NOVEMBER 5, 1987

STAFF REPORT  
(Final Plat; Preliminary Approved 9/24/87)

CASE NUMBER: S/D 87-91 - REFLECTION RIDGE COMMERCIAL

Re: Final Plat S/D 87-91 - REFLECTION RIDGE COMMERCIAL

**PRELIMINARY PLAT**

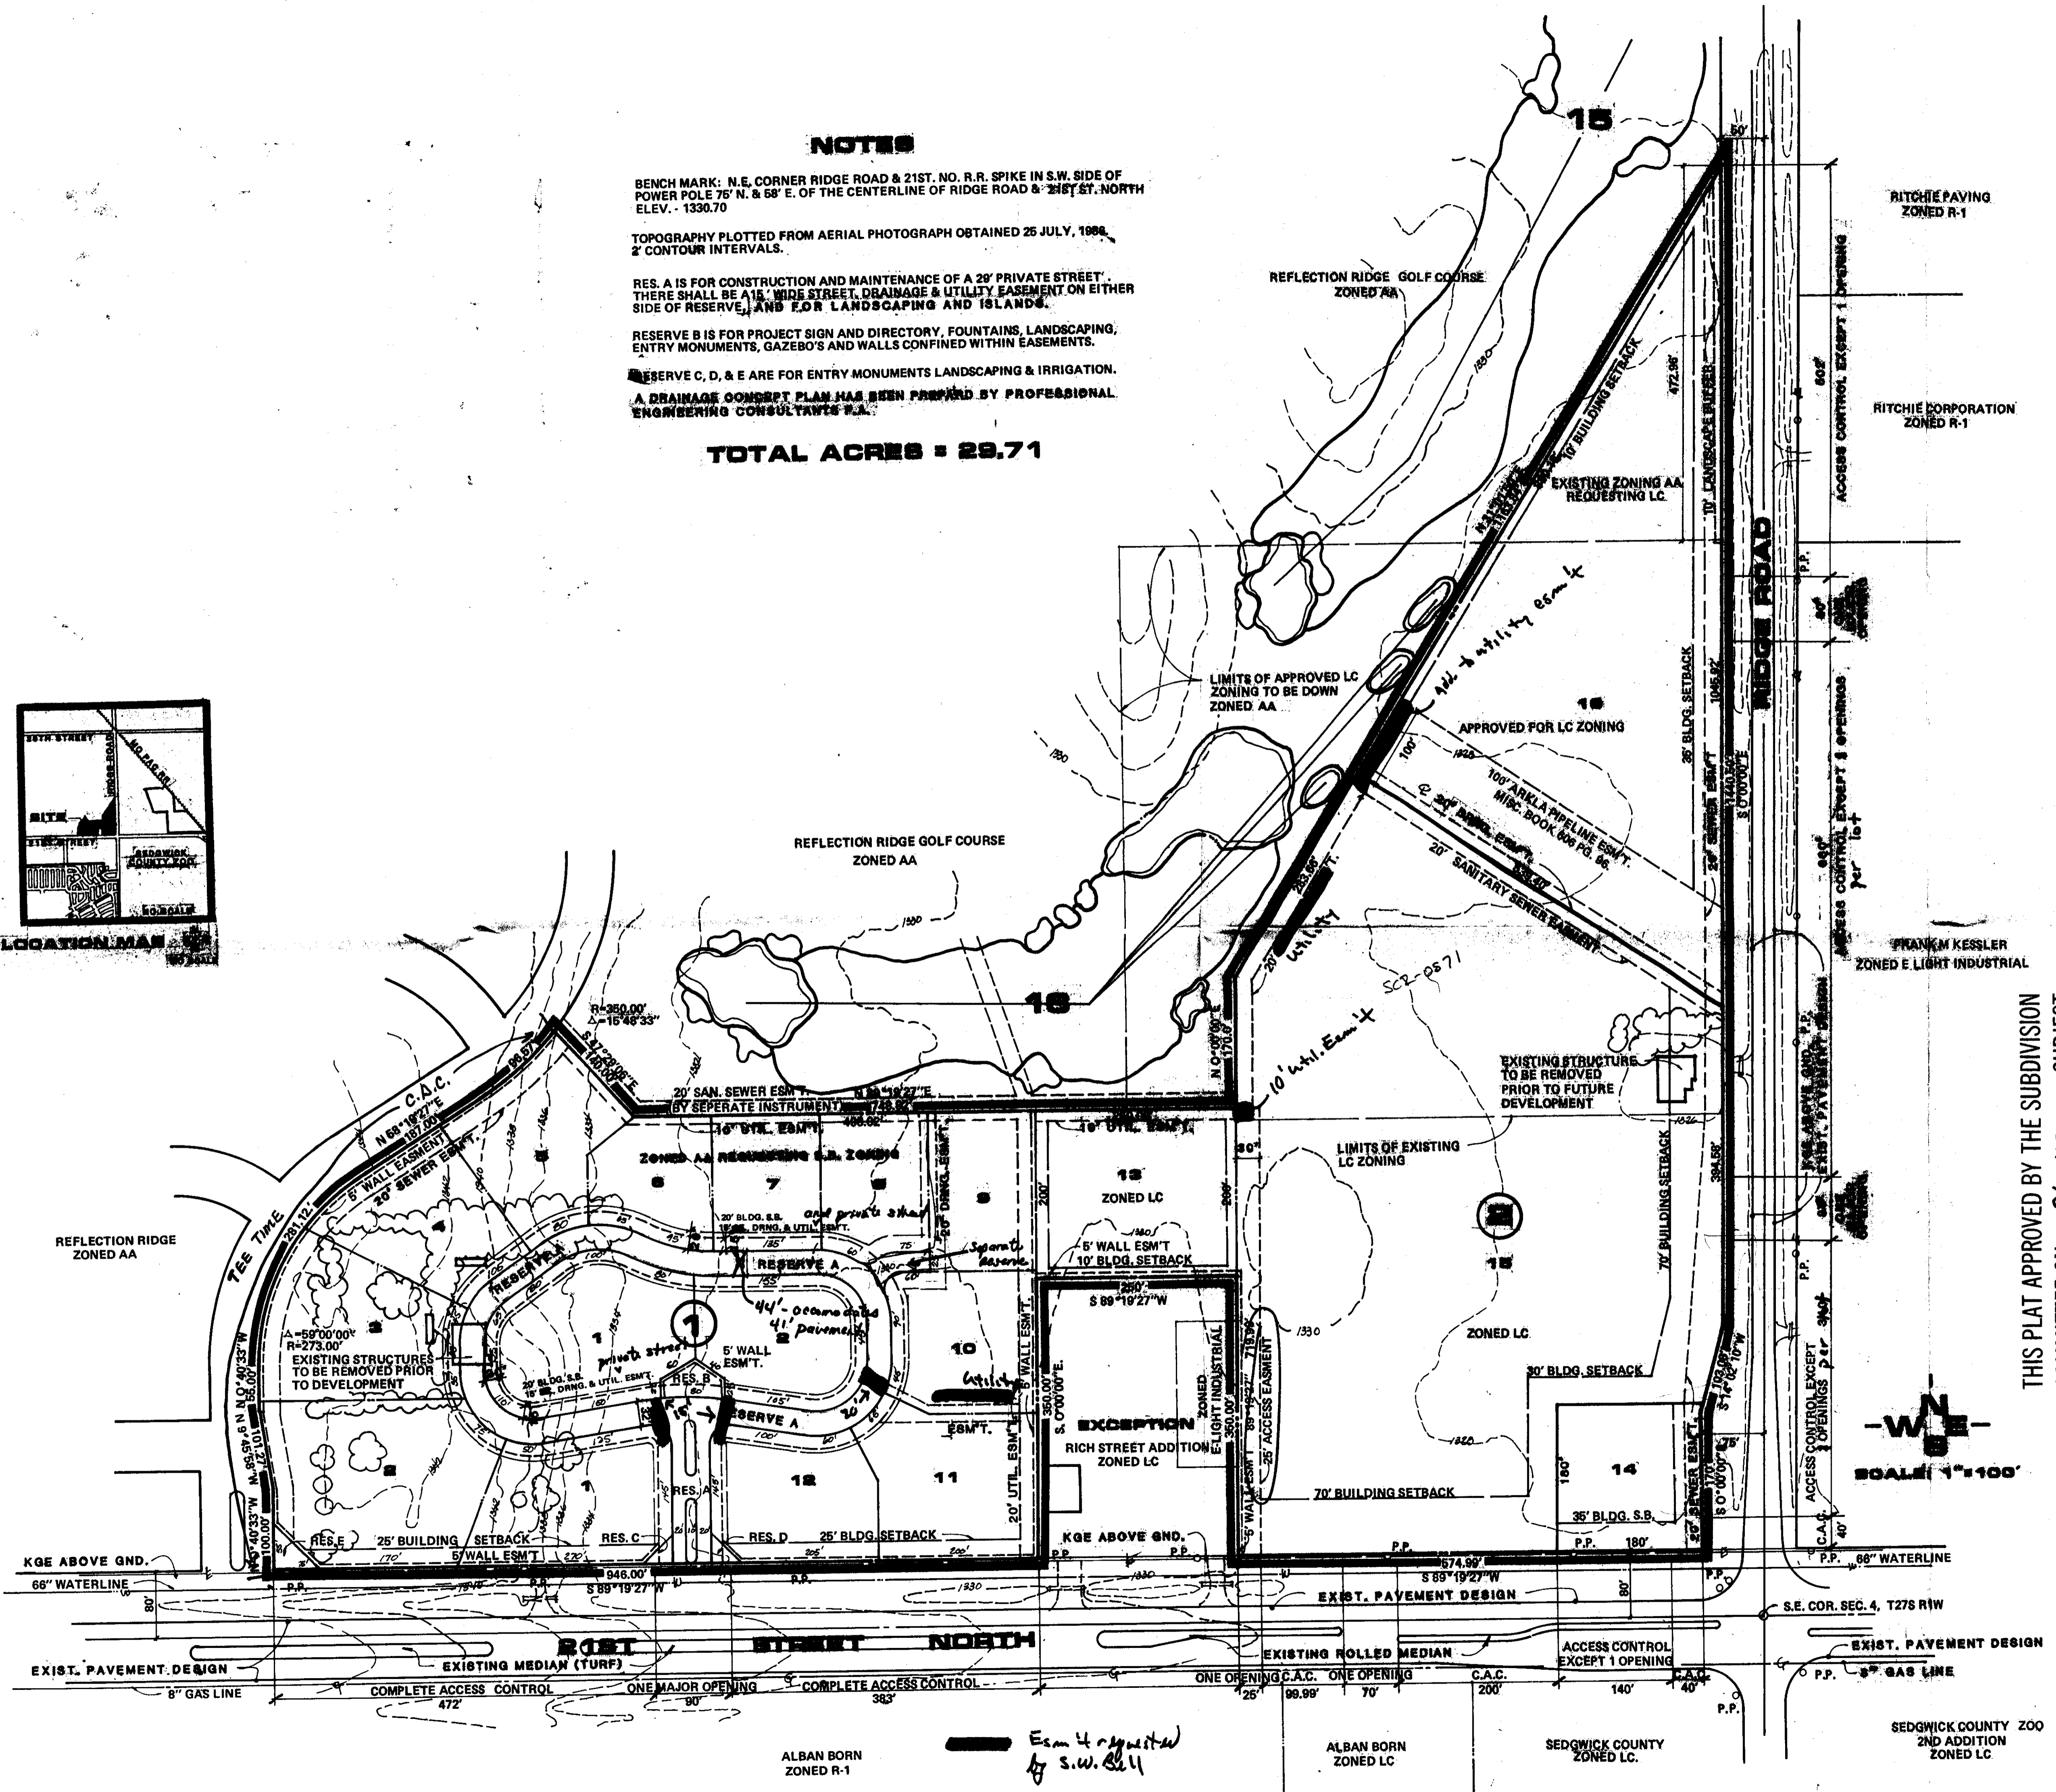
- N. Since building setbacks are being platted, the final plat tracing shall delete the note in the plat's text and on the face of the plat that states building setbacks are per the CUP.

- R. Perimeter closure computations shall be submitted with the final plat tracing. Section 5-101(C).
- S. Recording of the plat within 30 days after approval by the City Council.

- T. The representative from the City Engineer's office should be prepared to comment on the status of the applicant's drainage plan. Specifically, what drainage guarantees are required?

- A. The applicant shall guarantee the extension of sanitary sewer to serve the lots being platted.
- B. The applicant shall guarantee the extension of City water to serve the lots being platted.

- C. The applicant shall guarantee construction of the storm sewers required by this plat.
- D. The applicant shall guarantee any drainage improvements required by the platting of this property.

- E. As required by general provisions #5 of the associated Community Unit Plan, the applicant shall guarantee the following roadway improvements for 21st Street North and Ridge Road:

1. The applicant shall guarantee the reconstruction of the medial in 21st Street North to provide for an eastbound left turn lane or a fifth lane providing for left turn storage to serve Lots 1 through 12, Block 2 and Block 1 (proposed office park).

2. The applicant shall guarantee the construction of a temporary third lane for Ridge Road adjacent to this plat. As agreed at the time of CUP approval, this guarantee shall be held until development occurs. Partial development may necessitate partial construction of the third lane.

3. The applicant shall guarantee the construction of a fifth lane in 21st Street North to serve the permitted opening to Lot 15, Block 2. Also, the applicant shall guarantee a third lane in Ridge Road to accommodate left turns into the major entrances required to serve Lot 15, Block 2 and Lot 16, Block 2.

4. The applicant shall guarantee the construction of a decel lane on 21st Street to serve this plat. This guarantee shall provide for construction of that part of the major entrance, required to serve the proposed office park (Lots 1 through 12, Block 2), that is within street right-of-way. The applicant shall guarantee the construction of a decel lane on Ridge Road to serve this plat. This guarantee shall provide for construction of those parts of the two required major entrances that are within street right-of-way.

- H. The final plat shall state in the plattor's text the purposes of the proposed reserves as well as who is to own and maintain the reserves.
- I. On the final plat tracing, the reference in the plattor's text to Reserve A shall be amended to state that the reserve is platted for a private drive and not a street. Also, no reference to a street should be used on the 15-foot drainage and utility easement paralleling the private drive reserve. As was stated when the preliminary plat was approved with the "street to drive change", all lots within the office park will be assigned a 21st Street address and the private drive will not be given a separate street name.

- J. The applicant shall submit a copy of the instrument which establishes the Arkla Pipeline easement on this property. The applicant's agent should determine any setback requirements from the pipeline by researching the text of the pipeline agreement.

- K. The applicant shall provide proof, by letter from the pipeline company or by providing a copy of the pipeline easement agreement, that utilities and buildings may be located adjacent to the easement without restriction of an established setback from the easement.

- L. Any relocation, lowering or encasement of the pipeline, made necessary by this development, will not be at the expense of the City.
- M. The proposed joint access easement, on Lot 15, Block 2, will need to be established by separate instrument with appropriate recording information indicated on the final plat tracing. Prior to recording the joint access easement, a draft shall be submitted to the Planning Department for review
